VISUAL AND TECHNICAL CHANGE TO DEFLECTION PULLEY 58850

TECHNICAL INFO NO. 1013

RUVILLE-No.:	OE-No.:	Manufacturer:
58850	A000 550 13 33	Mercedes

Image 2: 58850 - new design

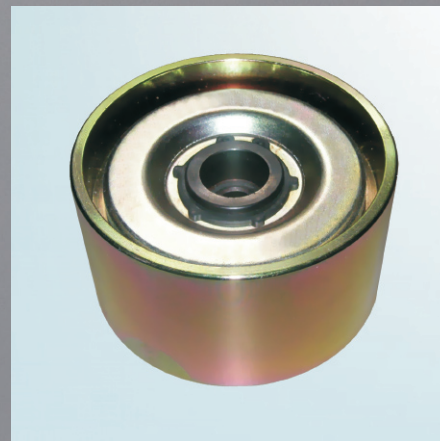
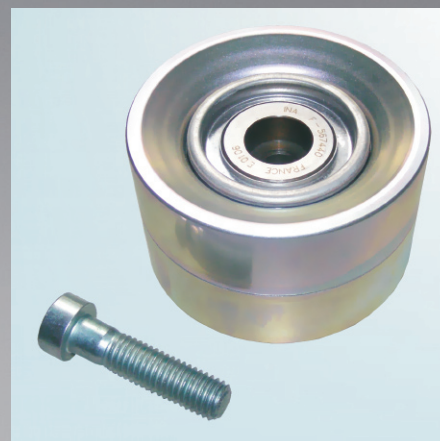
The new version is also supplied with an M10x40 bolt (see Image 2). This replaces the M10x35 fixing bolt with which the previous pulley (see Image 1) was attached. Note the specifications of the vehicle manufacturer!

Aside from the different production method and the 4mm wider pulley, the new pulley is lighter (657 g compared to 966 g for the old pulley).
